Our Ref: BJ/240524

4th March 2025

**RE: SECTION 4.55(2) MODIFICATION APPLICATION TO DA/2019/573/1
547 RAYMOND TERRACE ROAD, CHISHOLM (LOT 20 DP 832786)
TORRENS TITLE SUBDIVISION – 22 RESIDENTIAL LOTS, ROAD WIDENING AND
ASSOCIATED INFRASTRUCTURE**

Figure 1: Approved and Proposed Layout

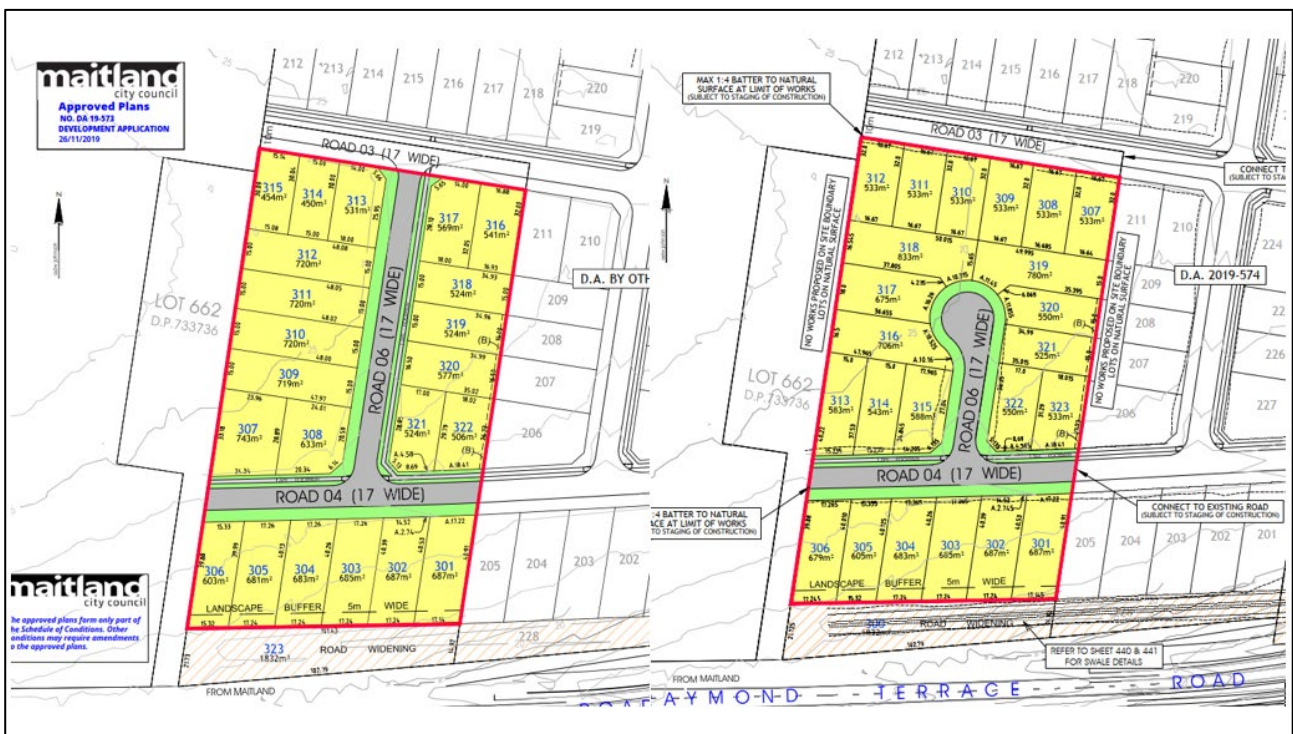
The amendments proposed revolve around altering Road 6 to a cul-de-sac arrangement. This in turn will increase the lot yield by one, as well as making minor reconfigurations to the associated lots.

The amendment to Road 6 will remove the connection to Road 3 which has been approved on the adjoining site to the north. In this regard, it is noted that the north/south connection is not a requirement of the Eastern Precinct Plan as illustrated within Figure 2, and its removal accommodates an additional housing opportunity which is considered pertinent in the current housing crises climate.

The approved and amended layouts are provided within Figure 1.

- Amendment to Road 6 to a cul-de-sac arrangement;
- Reconfiguration of the lot layout to accommodate above, including the addition of one lot;
- Split the staging of the development into three stages.

Figure 3: Staging Plan

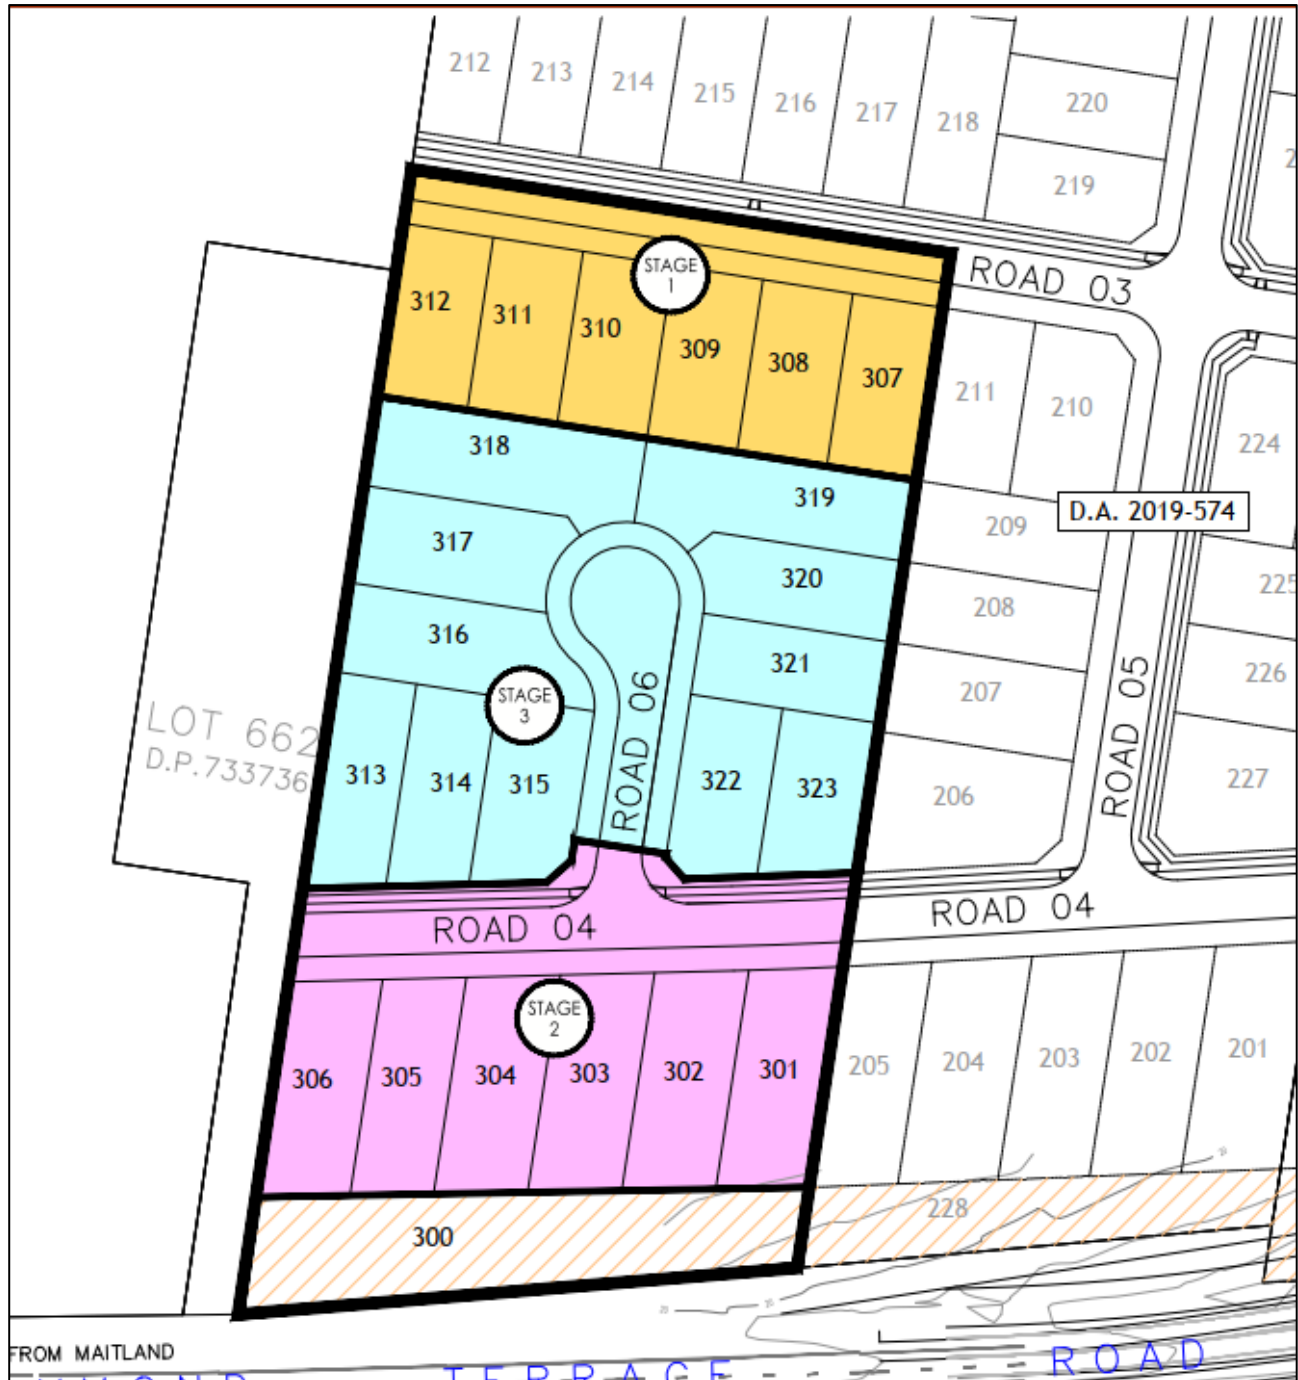
The proposed amendment also proposes the inclusion of staging as depicted within Figure 3 overleaf. The staging has been proposed to correspond to the anticipated timing of neighbouring developments and associated infrastructure.

- (a) Prior to the issue of a Construction Certificate for **Stage 1**, the Construction Certificate for DA2019/574 (Stage 1) must be issued and include construction of Road 03 to full width across both Construction Certificates.
- (c) The subdivision construction shall be carried out in the numerically consecutive stages as shown on the approved Context Staging Plan (DA-106).

STAGING PLAN

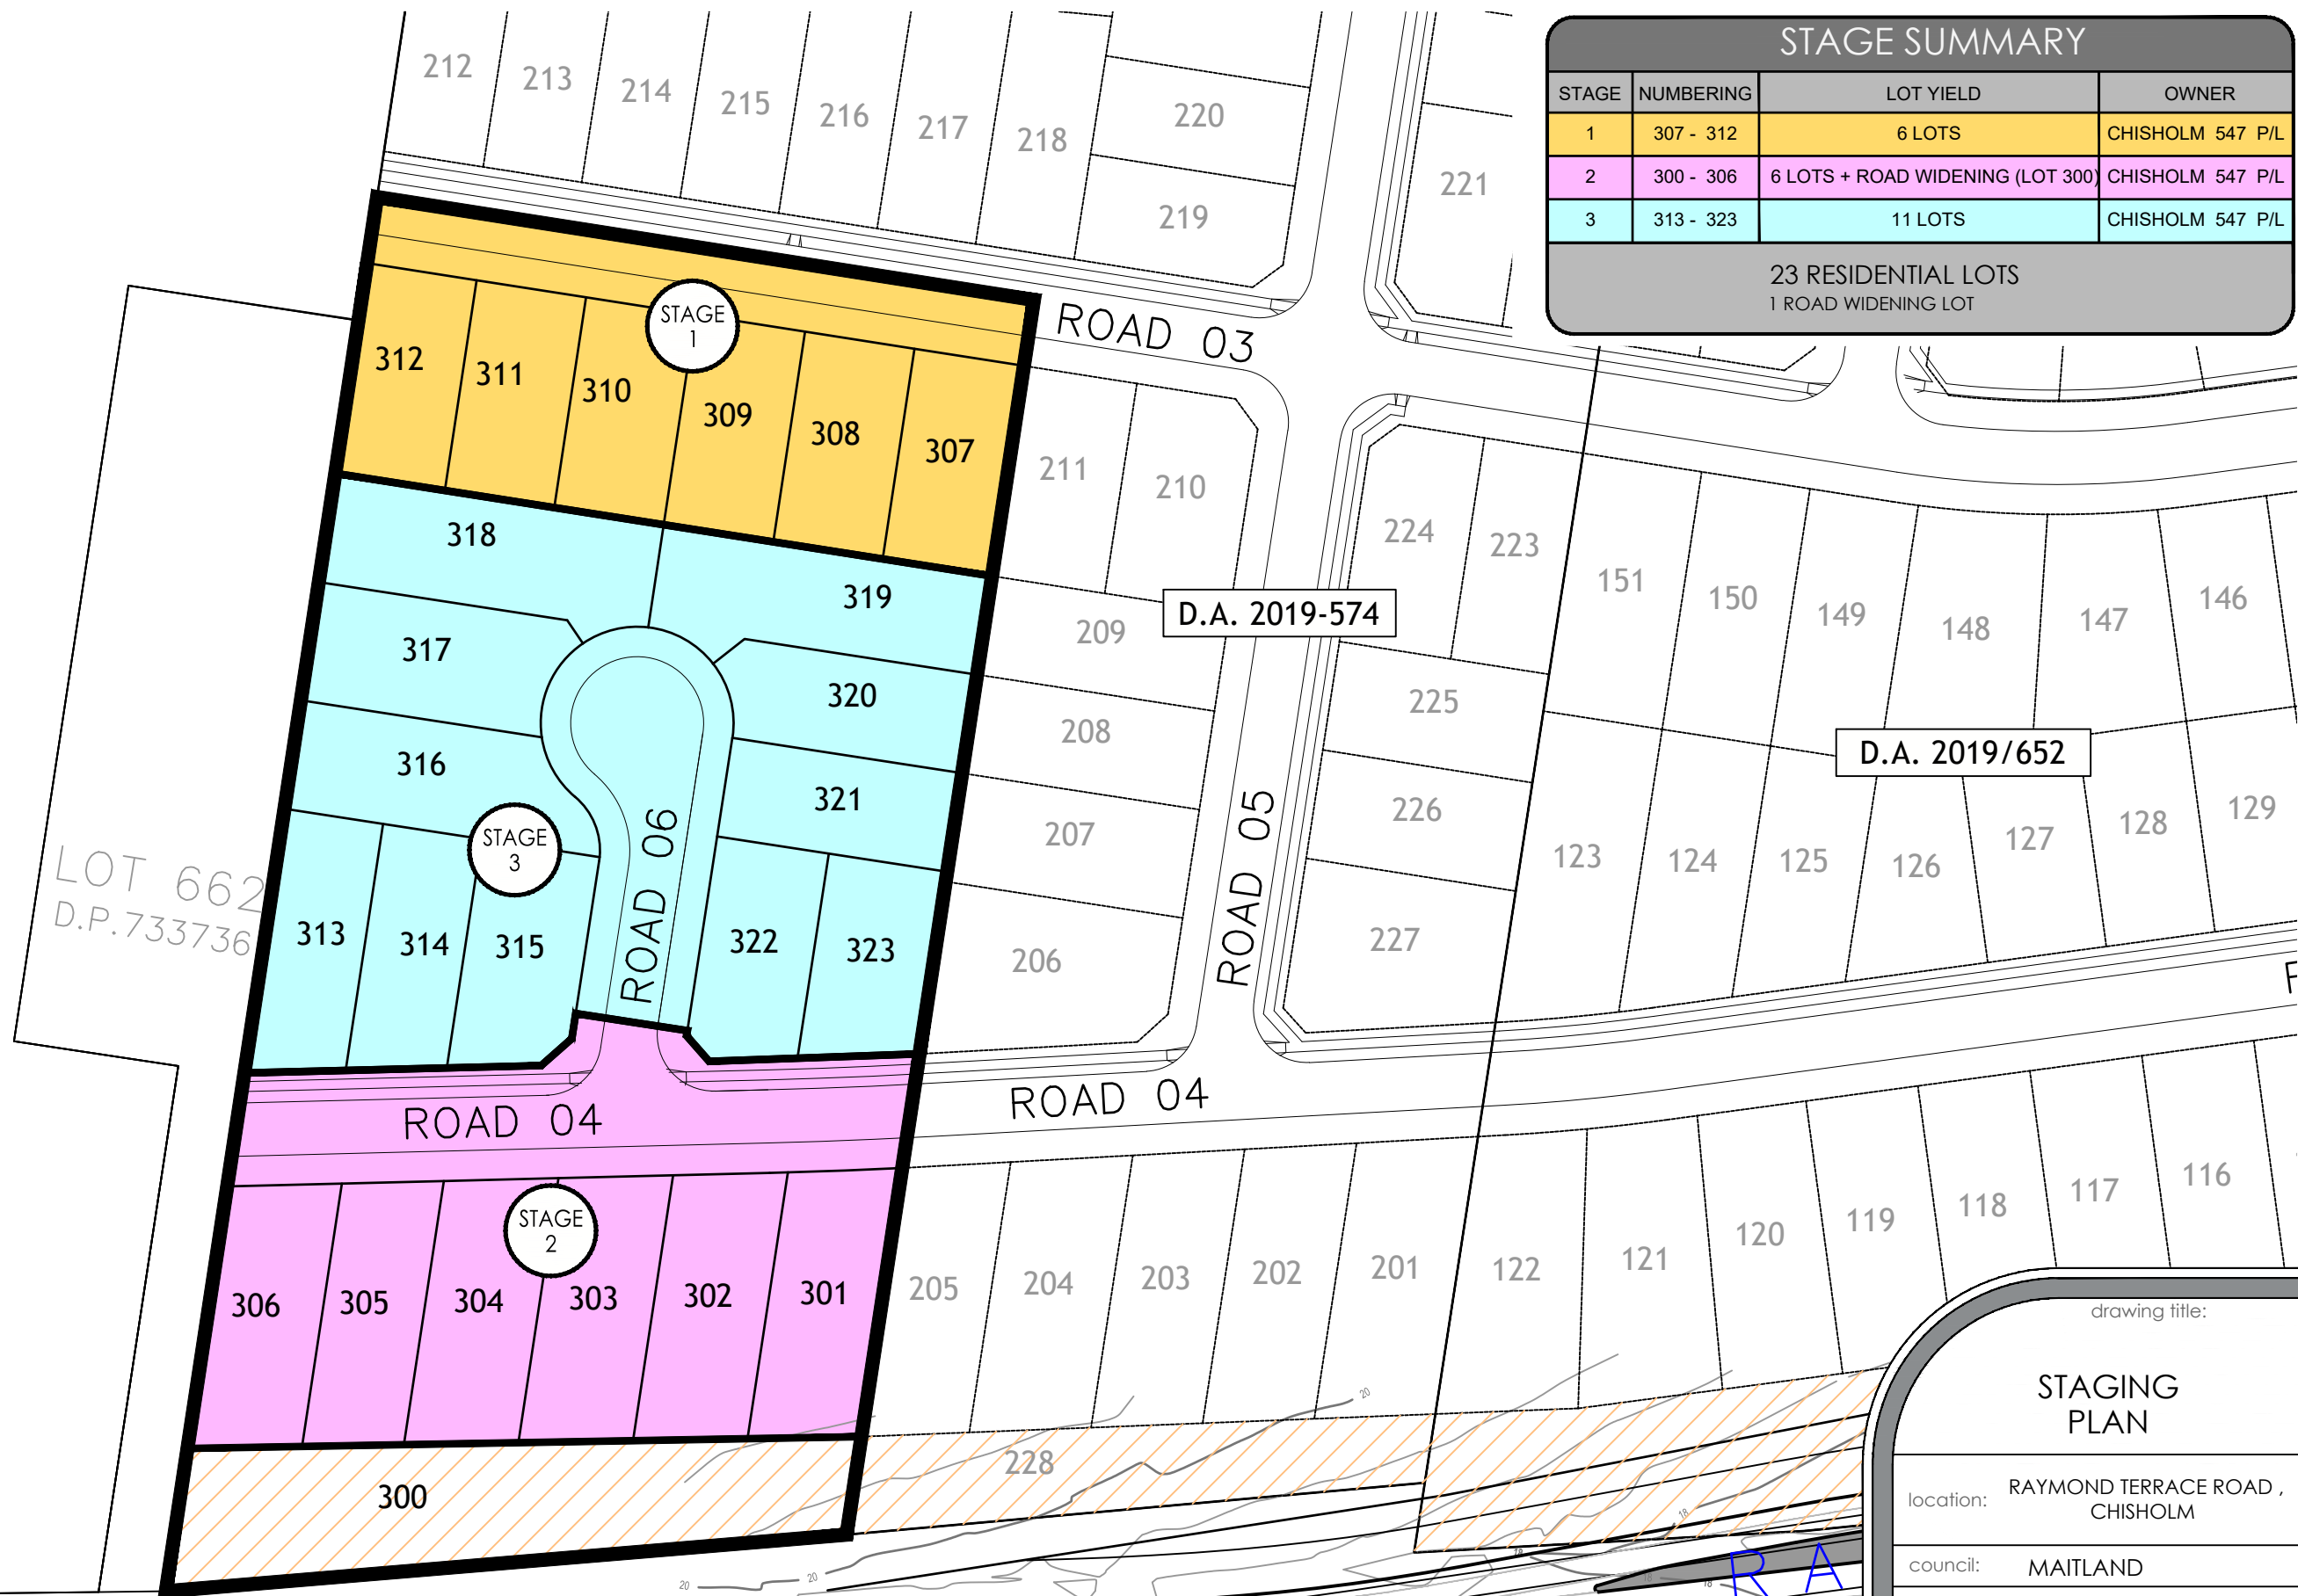
STAGE SUMMARY			
STAGE	NUMBERING	LOT YIELD	OWNER
1	307 - 312	6 LOTS	CHISHOLM 547 P/L
2	300 - 306	6 LOTS + ROAD WIDENING (LOT 300)	CHISHOLM 547 P/L
3	313 - 323	11 LOTS	CHISHOLM 547 P/L
23 RESIDENTIAL LOTS 1 ROAD WIDENING LOT
